Product Change Notification

Product Change Notification: E-20-017681

AMPSEAL 8-Position Vertical and Right-Angle Header Counterbore Addition

AMPSEAL Counterbore Addition – Before & After

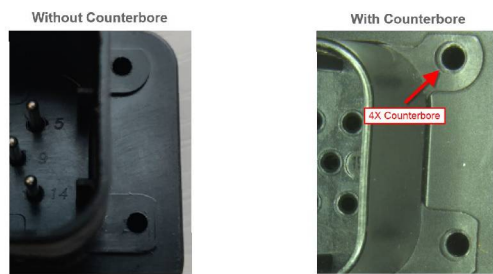
The Industrial and Commercial Transportation business unit of TE Connectivity is making a change to the mounting hole geometry on all 8-position vertical and right-angle AMPSEAL headers for the part number(s) listed below. These PNs are TE proprietary designs, therefore considered catalog/general market product. PPAP and/or sample requests must be submitted within 14 days of PCN submission via [ict-ppap-request@te.com](mailto:ict-ppap-request@te.com) or ePPAP system. Submission will not occur without request. If PPAP requested, disposition response is required within 14 days of submit date or it will be considered approved. Product drawing(s) are affected.

Product Improvement. Dear Customer, we hereby inform you of this change. The change is necessary to improve mounting capabilities. The change does not impact performance. IMPORTANT: The current and previous revisions of these parts can be used interchangeably in the field. The change(s) are being phased in gradually and previous revision can remain stocked until use. Shipments of both configurations may be mixed.
